PERMIT

P 32859

SEWAGE DISPOSAL SYSTEM

ADDRESS 13775 Triadelphia Road, Glenelg, Maryland 21737 PHONE 988-9270

PERMIT CARD

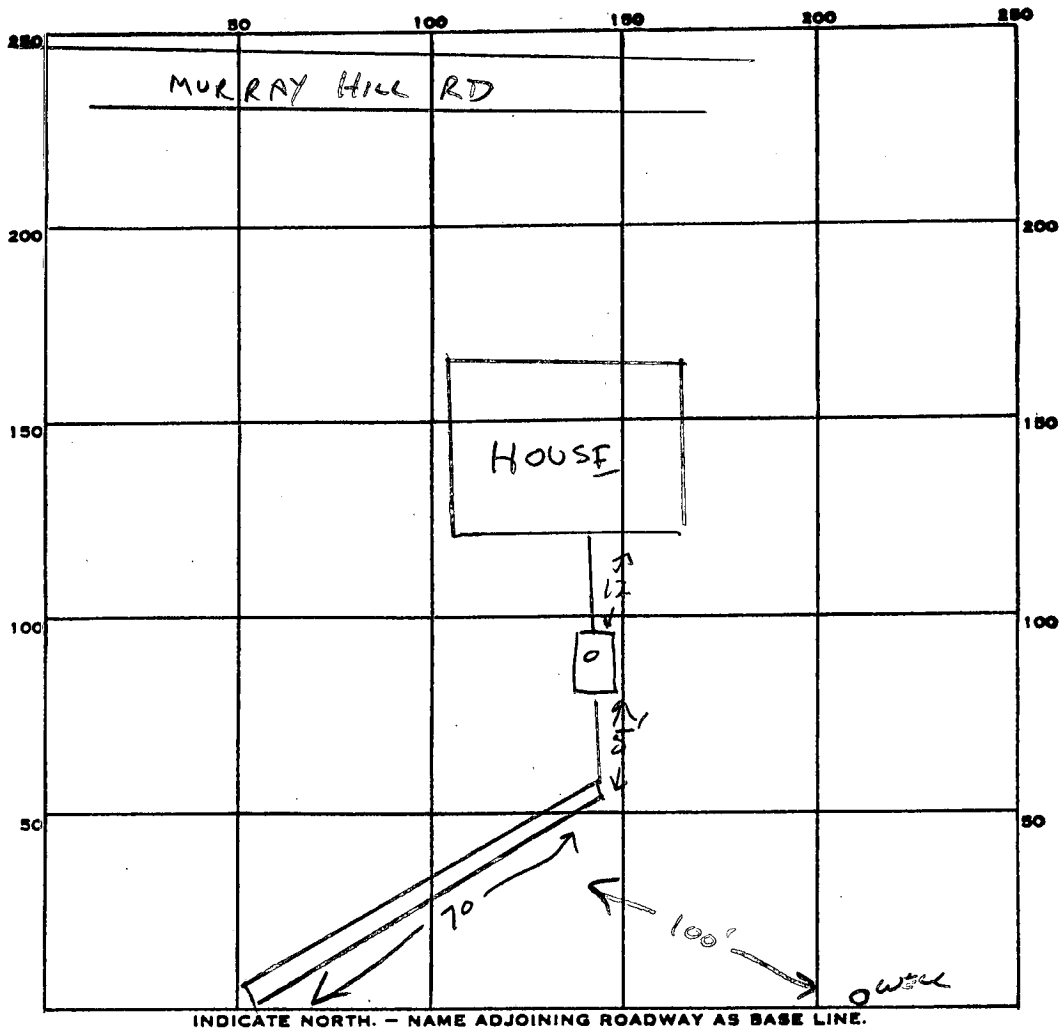
6/22/83 T.C. J. Fyock, no septic tank exists on lot, Tank & trench req'd T.S.

REMARKS TRENCH & GRAVEL OK. COVER. NEED TANK 6-23-83 CW
COMPLETE 6-23-83 CW

DATE SYSTEM APPROVED 6-23-83
